## **6. REGULATORY STATUS UPDATE**

### **6.3.1 *LAI Review of USCG Findings***

**Figure 55 – Anticipated LNG carrier transit route with Zone 1 (red), Zone 2 (yellow) and Zone 3 (blue)**<sup>233</sup>

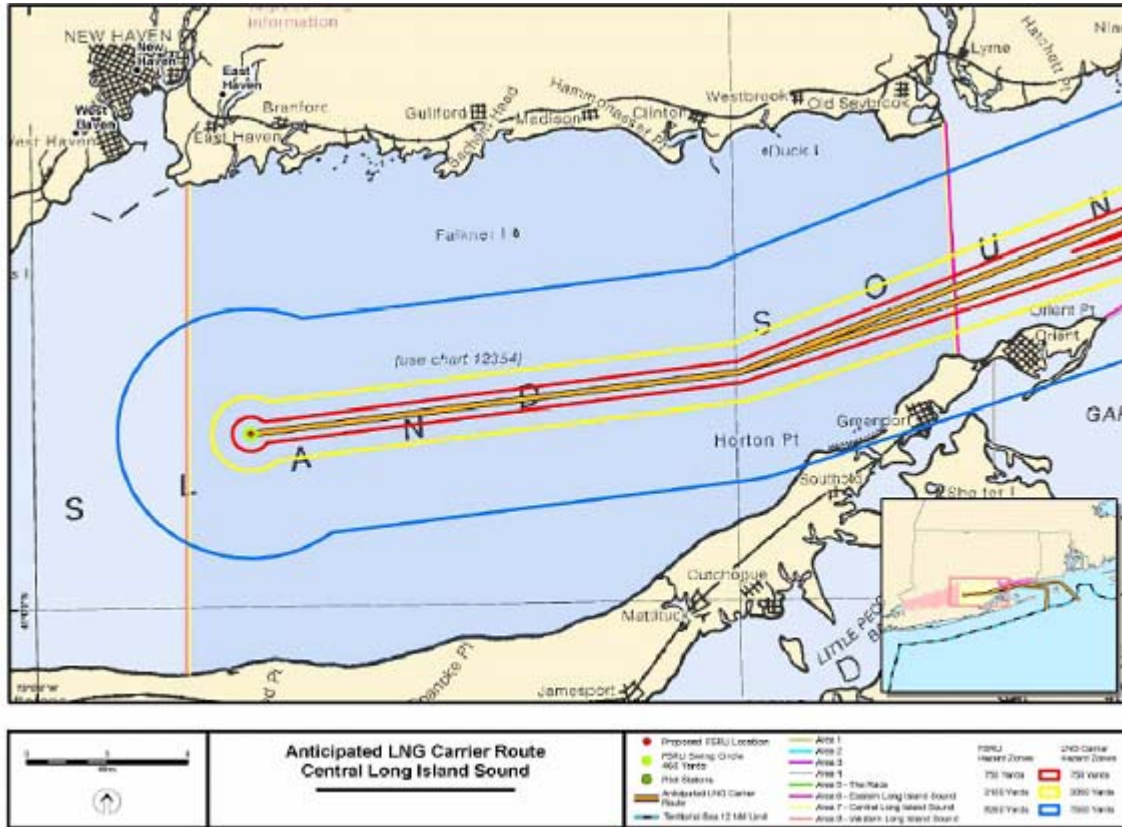
None of these hazard zones around the FSRU would impact any population centers due to their distance from land, shown in Figure 55.

Neither hazard Zone 1 nor 2 would impact land along the proposed LNG tanker transit route. However, hazard Zone 3 surrounding the proposed LNG carrier transit route encompasses Fishers Island, Plum Island, and the eastern portion of Southold, NY, as well as small portions of coastal Connecticut and Block Island, RI.

Figure 56 – LNG Carrier Anticipated Transit Route and Hazard Zones – The Race<sup>234</sup>

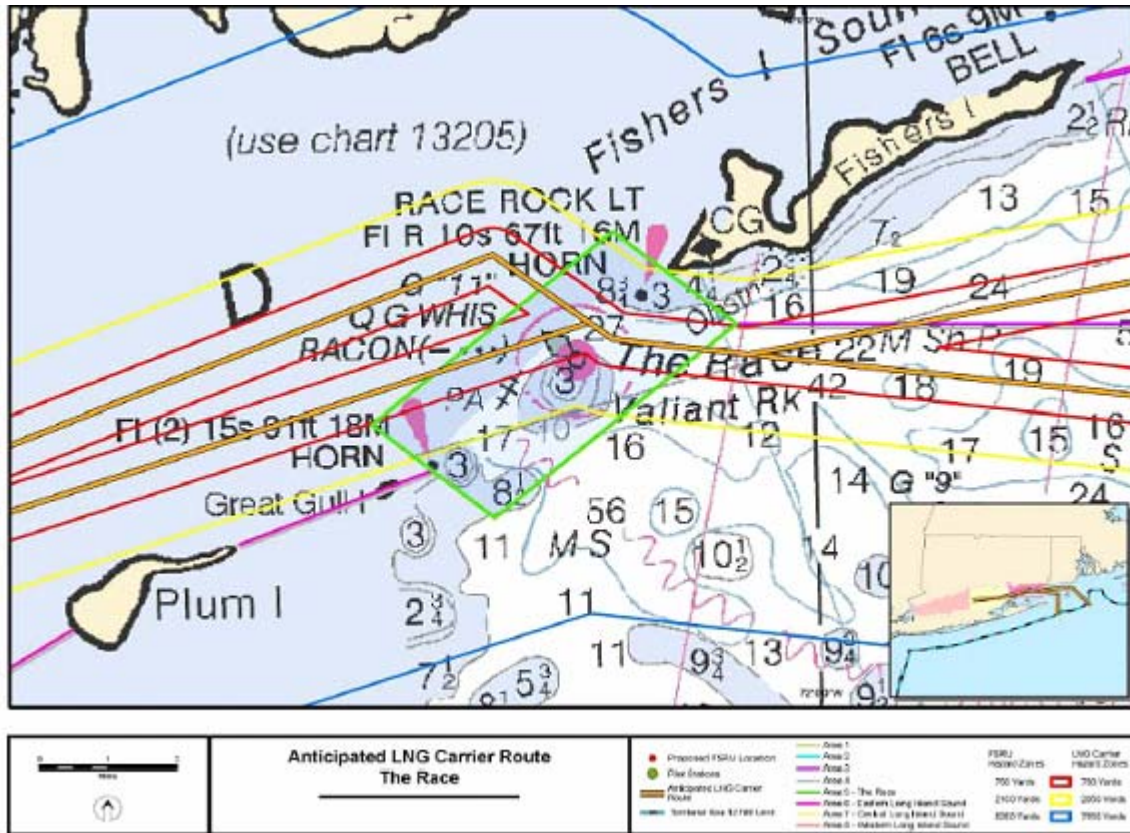
Although The Race, a 2,195 m wide channel, is considered a critical waterway for national defense, commerce and recreation, the impacts of the moving safety and security zone around the transiting LNG carriers on other waterway users is manageable according to the USCG. Assuming an LNG carrier travels in the middle of The Race, there would be approximately 389 m on each side of the safety zone where small craft could operate while LNG carriers are transiting The Race (Figure 56).

Figure 57 – LNG Carrier Anticipated Transit Route and Hazard Zones<sup>236</sup>

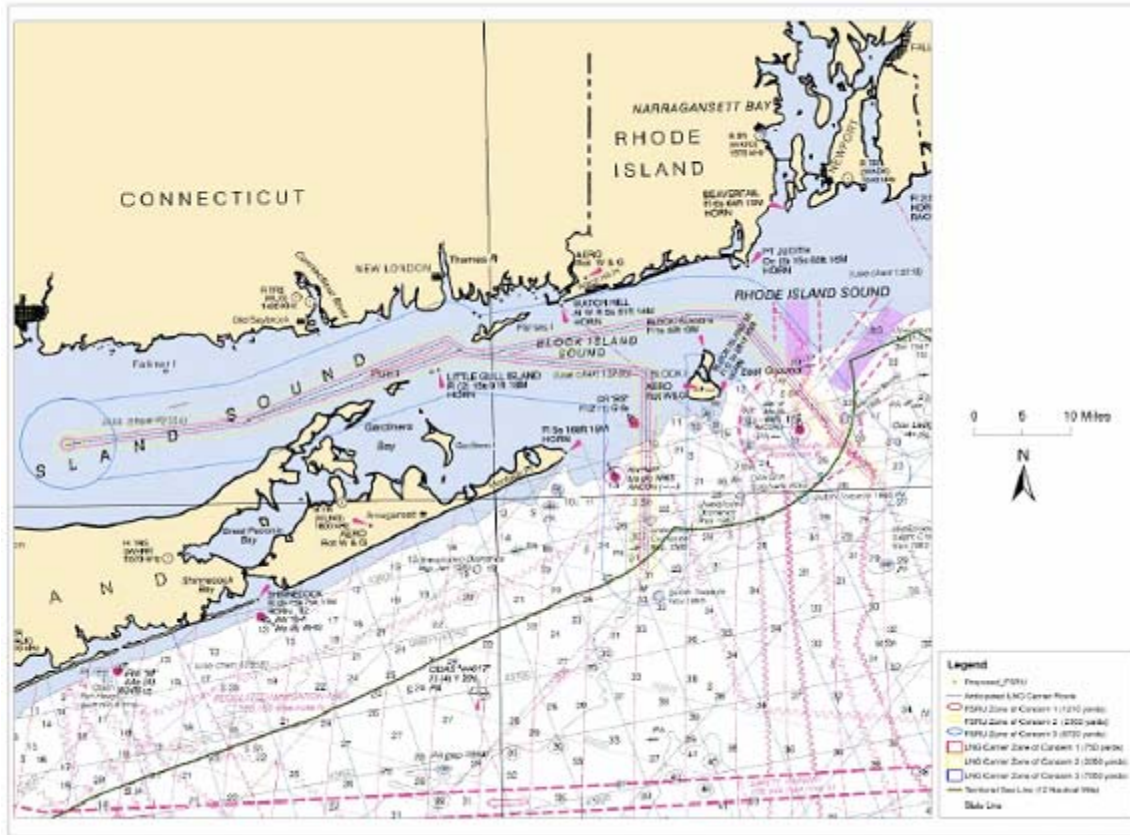
As seen in Figure 57 , the 1,106 m safety / security zone (Zone 1) around the FSRU crosses New York and Connecticut waters. Additionally, parts of Zones 2 and/or 3 around both the FSRU and LNG carriers cross New York, Connecticut and Rhode Island waters. Zone 3 crosses Fishers Island, Plum Island, and the eastern portion of the Town of Southold, NY, a sliver of coastal New London and Waterford, CT, and a very small portion of Block Island and Westerly, RI. Earlier this year, both the Commissioner of the CTDEP and the Connecticut Attorney General submitted letters to FERC requesting that Broadwater be required to file for a Coastal Zone Consistency determination with the CTDEP.<sup>235</sup> No Rhode Island agency has filed for permit authority at FERC.

Figure 58 – Alternative Terminal Sites and Pipeline Routes Considered by Broadwater

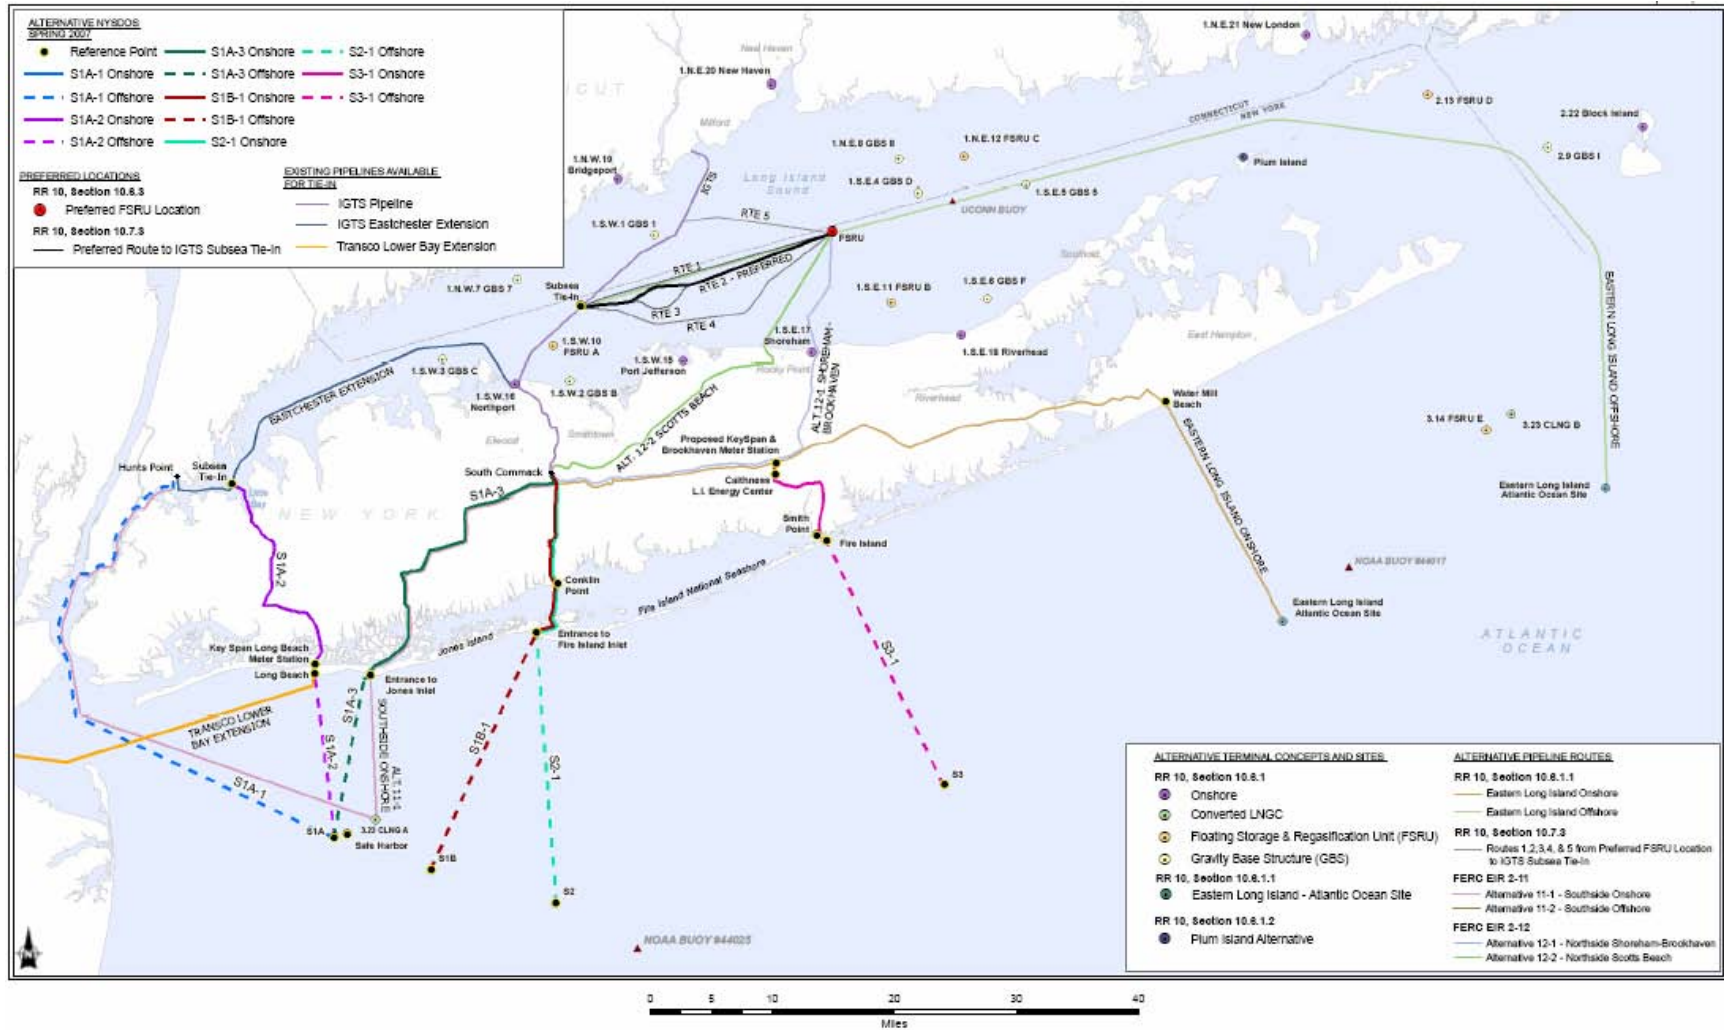
Of these six sites, of particular interest to LIPA is site S3-1 (Figure 58) which is an eastern facility location with an offshore pipeline route coming into Fire Island and an onshore pipeline route through Smith Point with a tie-in to Iroquois' proposed Brookhaven Lateral project at the Caithness Long Island Energy Center. This site seems to have fewer negative impacts than the other five pipeline routes. The pipeline would be 33 miles long, would only affect 10 residences adjacent to the construction ROW and involve three major shore crossings.
